Molly McGuire  
Mercer Island Community Planning and Development Department  
RE: Clarifications on Building Permit 2207-019 SUB4  
June 28, 2023

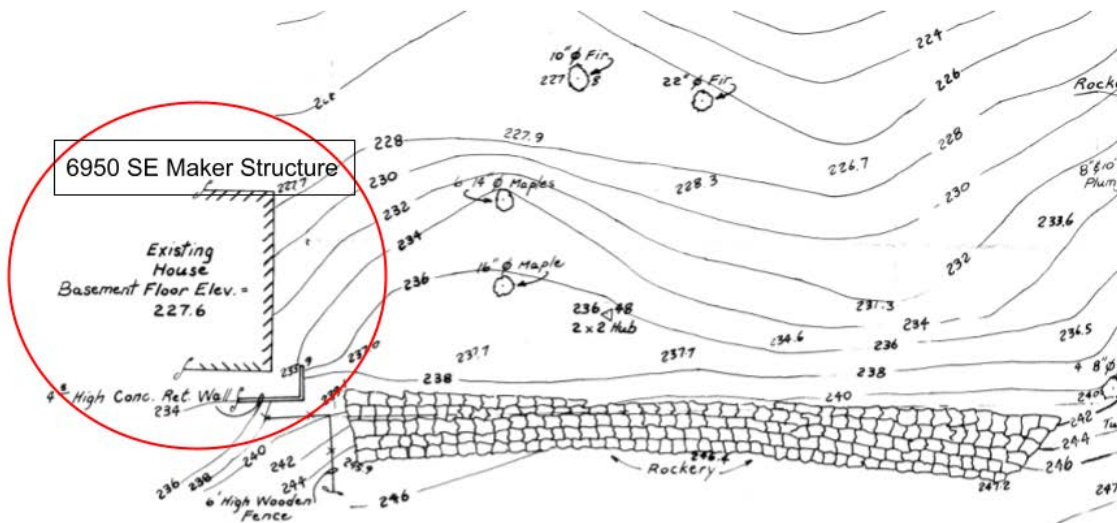
The D.R. Strong survey is from 7415 SE 35th Street, and was obtained from the Mercer Island GIS for 7145 SE 35th (link from GIS is [here](#), site plans with the address and matching contours is found [here](#)). The 6950 SE Maker structure is clearly shown in this survey and highlighted below. In fact, the SUB4 letter from Mr. Miller (Terrane Inc.) agrees that this survey closely matches the northern boundary of 6950.

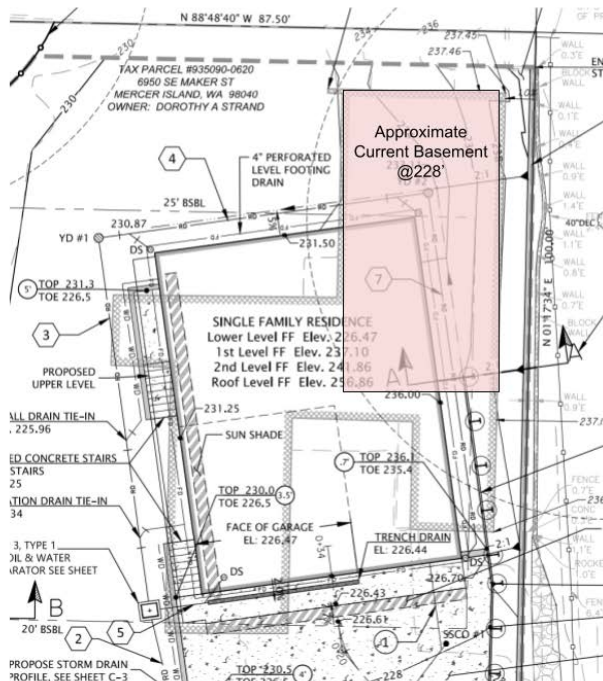
Finally, none of the submissions made to date have acknowledged that the northeast portion of the proposed structure sits on a walk-out basement slab at a grade of 228', shown below.
